Product Change Notification / ALAN-19MXBI828

CCB 4798 Final Notice: Qualification of MMT as an additional assembly site for selected ATXMEGA128xx and ATXMEGA64D4xx Atmel device families available in 44L VQFN (7x7x1mm) package

PCN# ALAN-19MXBI828

Pre and Post Change Summary

ASE Inc (ASE)

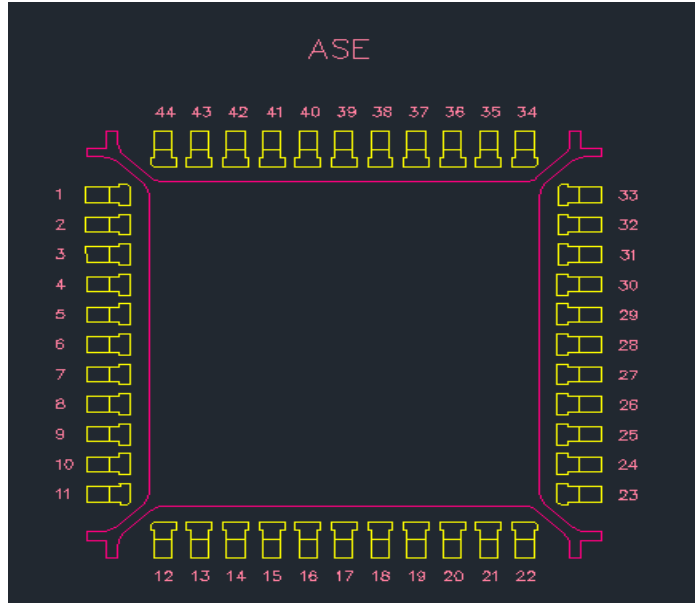
Lead-lock

No

Microchip Technology Thailand (Branch) (MMT)

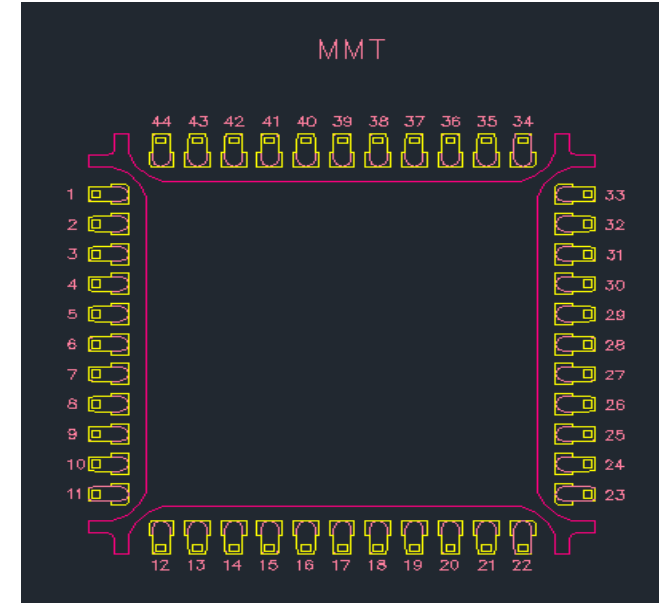
Lead-lock

Yes

*Note: Mold compound material fills the lead lock hole, which provides improved protection against moisture penetration along the edge of the leads (pins) of the package.”
